## SUMMARY

JRPP Ref No.	2010SYW046
DA No:	DA/374/2010
Assessment Officer:	Michael Tully
Property:	LOT 24 DP 200061, 9 Nulang Street, TOONGABBIE NSW 2146
Proposal:	Construction of a carport at the front of the dwelling.
Date of receipt:	12-May-2010
Applicant:	Starport Constructions Pty Ltd
Owner:	NSW Housing.
Submissions received:	Nil
Property owned by a Council employee or Councillor:	No
Issues:	Carport dominance (beyond front building line) and streetscape.
Recommendation:	Refusal. (Crown application)

SITE PLAN  
SCALE 1:200

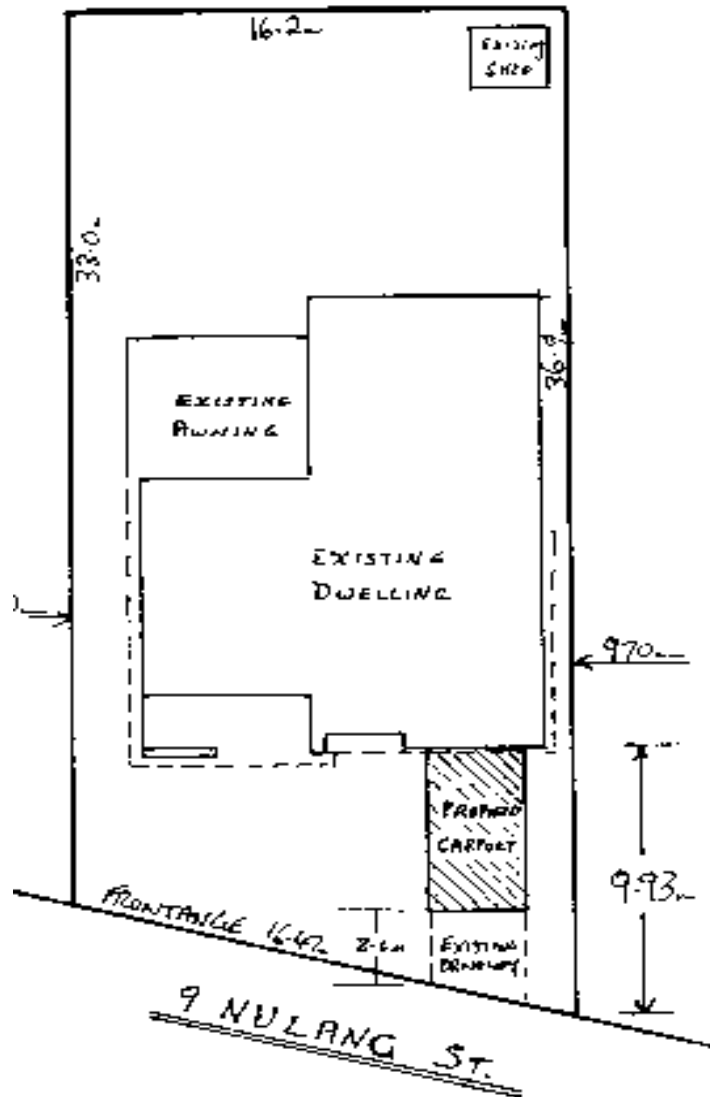
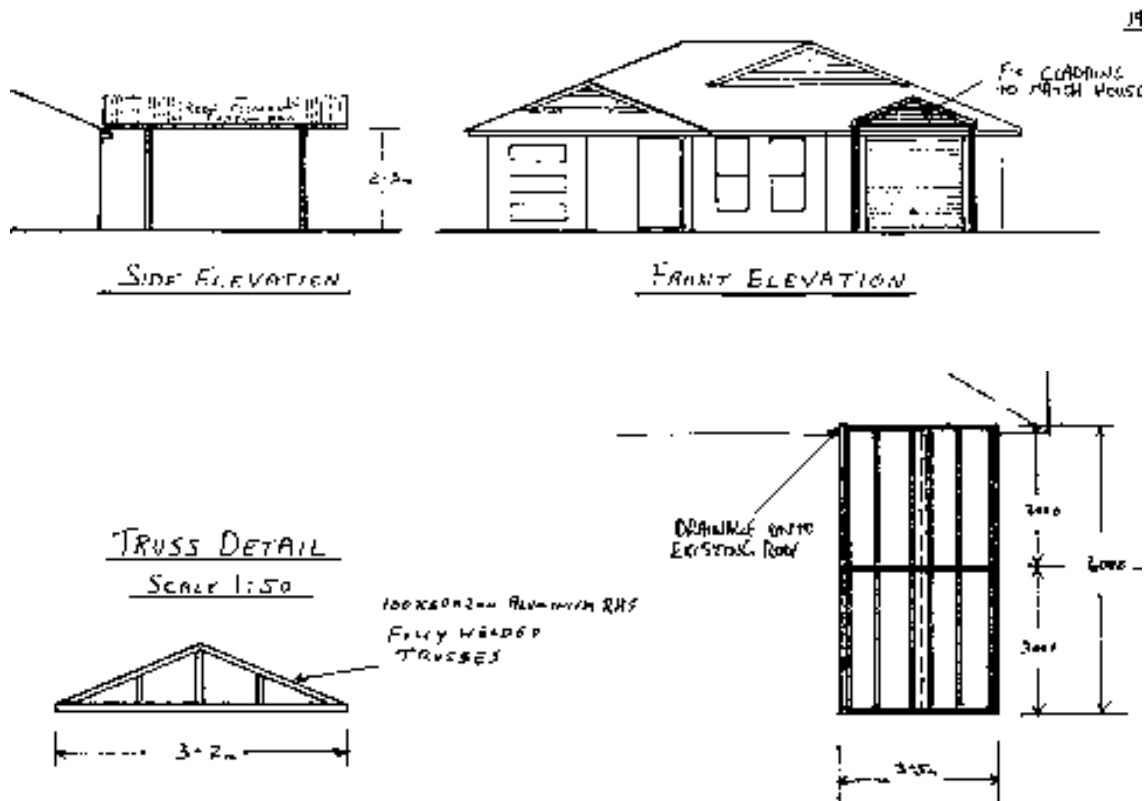
The plans submitted indicate the carport is to be constructed over the single car space, with a setback from the front boundary of 2.6m, which results in the entire structure being located forward of the building line.

The proposed carport will dominate the front façade of the dwelling. The construction of the carport within the front setback together with the gable roof design further enhances the bulk of the structure from the street. Although there are a couple of examples of single carports within the front building setback within Nulang Street, these carports pre-date Council's current DCP requirements and are not deemed to reflect the prevailing character of the street (see appendix for photos and plans) . There are also examples of carports within the street, which are larger than the one proposed, however these are located behind (or flush with ) the front building line, thereby integrating with the dwelling and not dominating the streetscape.

The proposed single car carport is entirely forward of the front facade of the dwelling. The majority of carports/garages within Nulang Street are located behind the building line or within the rear of the property. Relocation of the carport is not feasible as there is no space available on site to accommodate the carport behind the facade of the dwelling.
